RE: DENDROBIUM MINE – INDEPENDENT EXPERT SCIENTIFIC COMMITTEE RESPONSE TO EIS SUBMISSION

RESPONSE TO IESC COMMENTS

Figure 1 – Groundwater Level Monitoring Locations

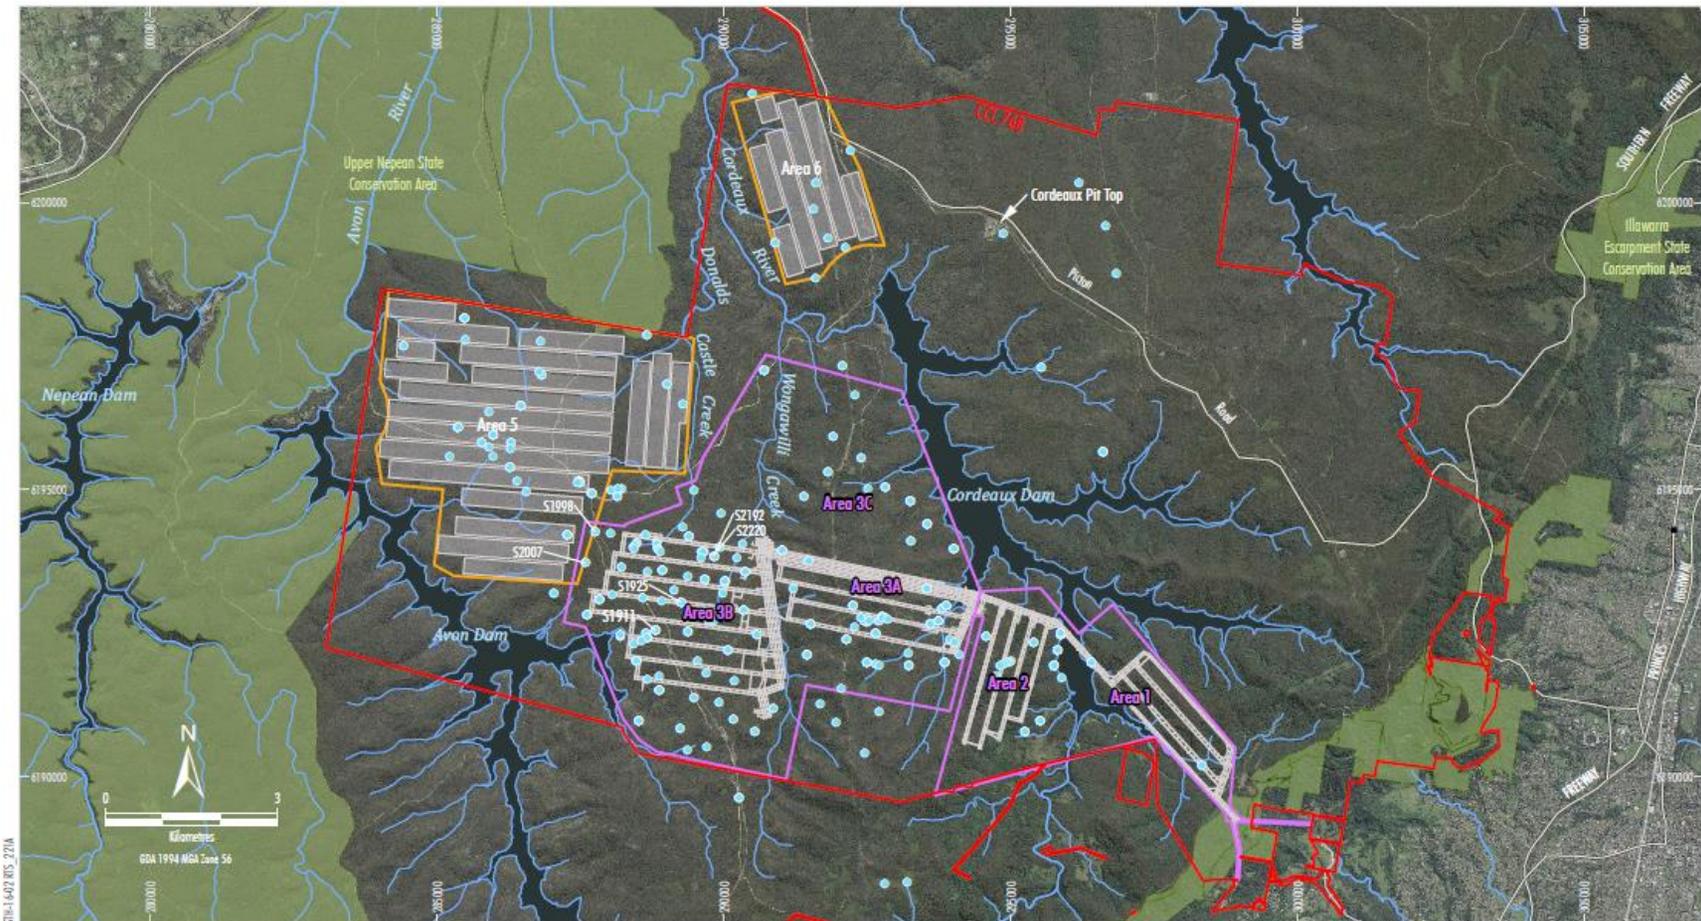
- a. *not all 26 swamps in Areas 5 and 6 are currently being monitored, potentially limiting swamp-specific information on their current condition. Baseline surveys (of suitable spatial and temporal extent – see response to question 12) of all swamps should be completed before any longwall approaches within 400 m of a swamp (i.e. before impacts due to ground movement occurs at the swamp).*

Baseline water level (including both perched aquifer and Hawkesbury Sandstone groundwater level) and soil moisture monitoring has been undertaken by South32 within underground mining Area 5 and Area 6 since 2017 (Figure 1).

Figure 2 – Surface Water Flow Monitoring Locations

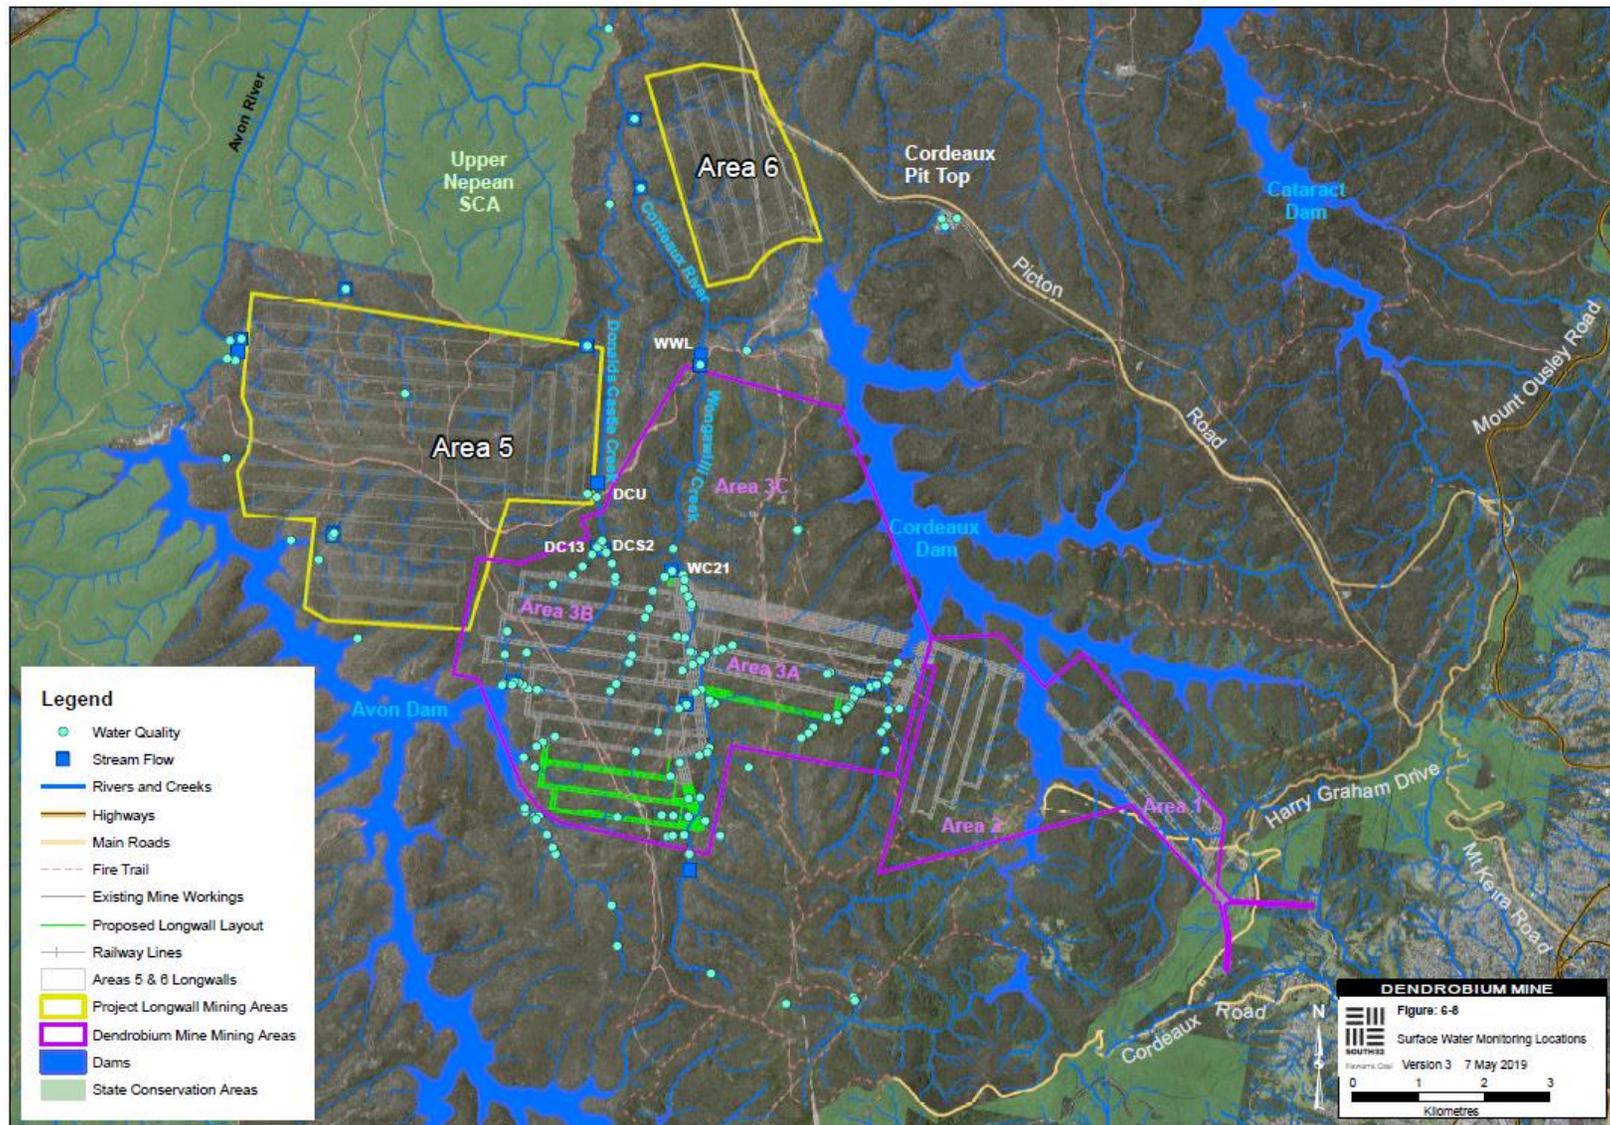
There is an unknown quantity of water lost via tortuous flow paths including fractures and bedding plane separations and shears in deeper strata overlying longwall panels (PSM 2017) and associated peer reviews including Mackie (2017) for a discussion of such processes. Accordingly, it is possible that a component of surface water flows may not be returned to the upland swamps and streams. The implications of this potential water loss for creeks and groundwater-dependent ecosystems during long-term operations and recovery of water levels after closure need to be considered in a manner that bounds the likely upper and lower range of impacts.

- For example, with respect to Donalds Castle Creek (DCU), the reduction in median flow at DC13S1 and DCS2 represents approximately 45 to 60% of median flow at the downstream gauge DCU. If the losses at DC13S1 and DCS2 were permanently lost from the catchment, then this reduction should be apparent at DCU (which is not the case). This indicates that the majority of the flow lost in the headwaters does re-emerge downstream. This does not equate to a finding that there is no change in the pattern of flow at DCU, because some changes to very low flows are likely, however the consistency of median flow is an indicator that the overall volume of flow is the same (Figure 2).

Specifically, in regard to Donalds Castle Creek, monitoring at the Dendrobium Mine shows that at stream flow gauges located above or immediately downstream of Area 3B (e.g. DC13S1 and DCS2 [refer to Figure 2]) loss of surface flow has been observable and discernible. Losses at these sites can be significant, with reductions in median flow being approximately 50-80% of pre-mining median flow.

Figure 6 – Groundwater Model Layering (Cross-section SW to NE)

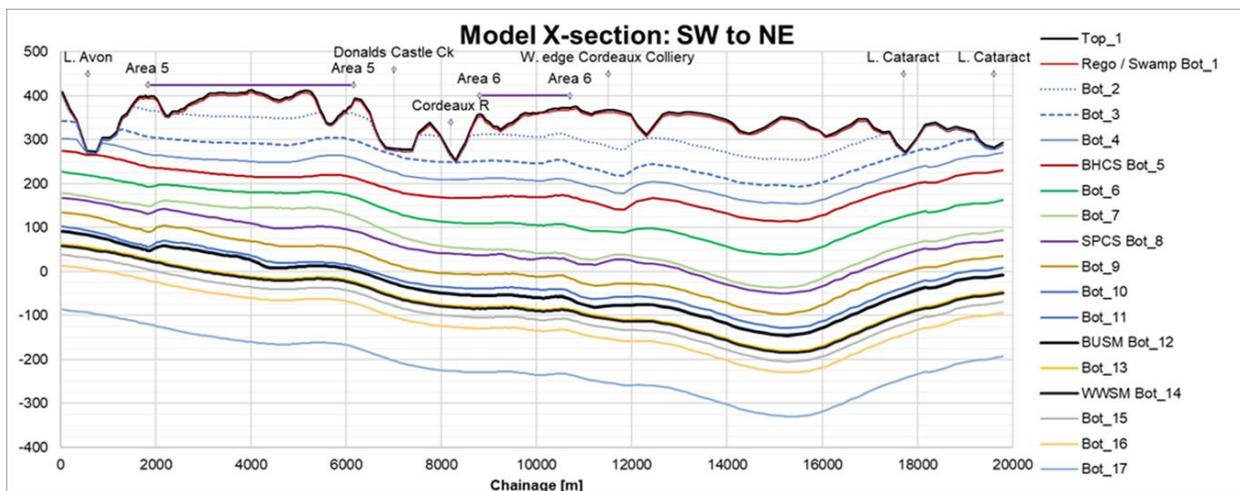
- a. As cross sections used to develop the groundwater model appear to be incomplete in representation of faults and strata thicknesses these need to be revised to be consistent with physical processes of deposition and movement.*

The stratigraphic layering (from the Illawarra Coal geological modelling) and the groundwater model layering are summarised in Tables 3-1 and 6-2 and Figures 3-4 to 3-6 of the Groundwater Assessment (Appendix B of the EIS), as well as Figure 6 which shows groundwater model layering.

With respect to the difference between ~4 m and 7 m thickness for the Wongawilli Seam, within the Dendrobium Mine lease, the groundwater model simulates only the working section (approximately 4 m) of the Wongawilli Seam. In areas away from mining, the model simulated the full thickness of the seam.
